APPLICATION NO.	FILING DATE	FIRST NAMED INVENTOR	ATTORNEY DOCKET NO.	CONFIRMATION NO.
09/437,296	11/09/1999	MICHIO YAMAJI	991283	7789

Office Action Summary	Application No. 09/437,296	Applicant(s) YAMAJI ET AL.	
	Examiner Aaron M. Dunwoody	Art Unit 3679

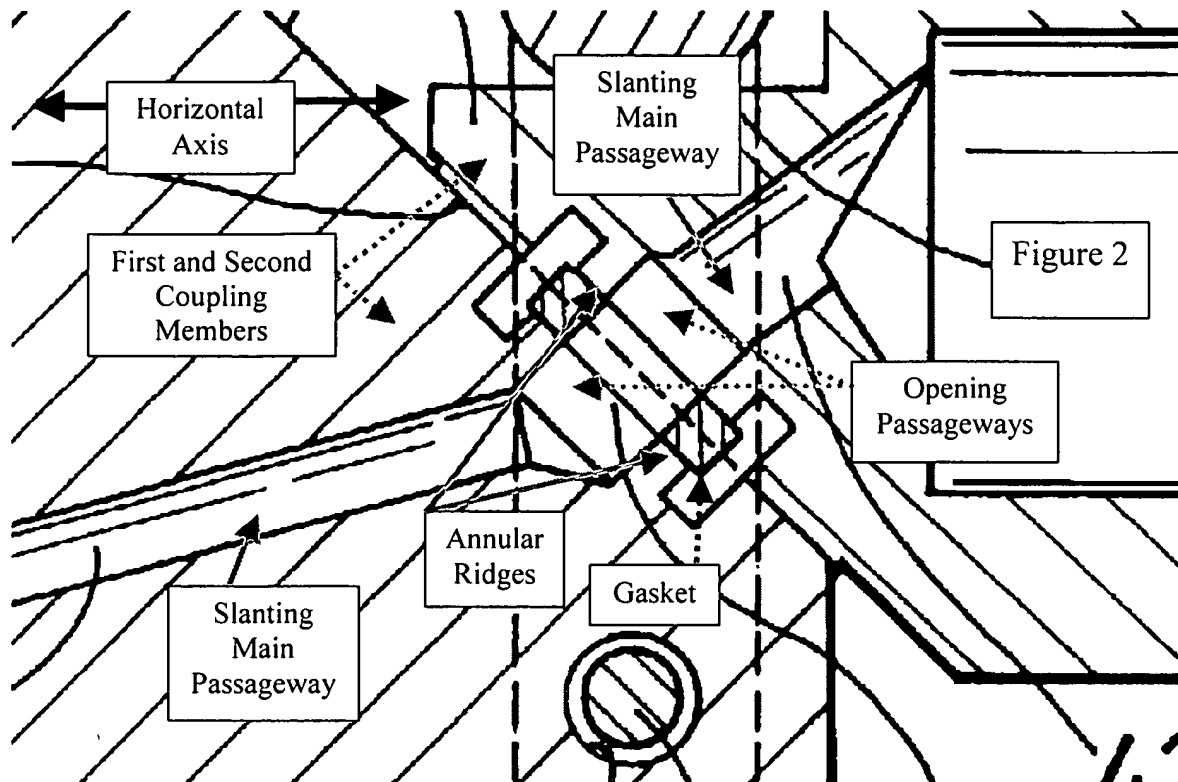
In regards to claim 1, in figure 2 below, Nakazawa et al discloses a fluid coupling comprising first and second coupling members having respective gasket holding annular ridges on butting end faces thereof; and

an annular gasket interposed between the first and second coupling members, wherein each coupling member has a fluid channel comprising an opening passageway orthogonal to the butting end face thereof, and a slanting main passageway communicating therewith, the opening passageway having a diameter equal to the inside diameter of the gasket holding annular ridge, and

the gasket holding annular ridges are in contact with the gasket at its radial midportion so as (capable) to relieve the inner peripheral portion of the gasket from stress concentration and wrinkles.

Nakazawa et al does not disclose the gasket holding annular ridges being rounded as to be in contact with flat, non-inclined faces of the gasket only at its radial midpoint. In Figure 5, Eidsmore teaches a gasket holding annular ridges (40) being rounded as to be in contact with flat, non-inclined faces of the gasket (42) only at its radial midpoint because this a relatively conventional arrangement well known in the art (col. 4, lines 24-26). As Eidsmore relates to pipe joints employing a metal gasket, it would have been obvious to one having ordinary skill in the art the time the invention was made to fabricate rounded gasket holding annular ridges as to be in contact with flat, non-inclined faces of the gasket only at its radial midpoint because this a relatively conventional arrangement well known in the art, as taught by Eidsmore.
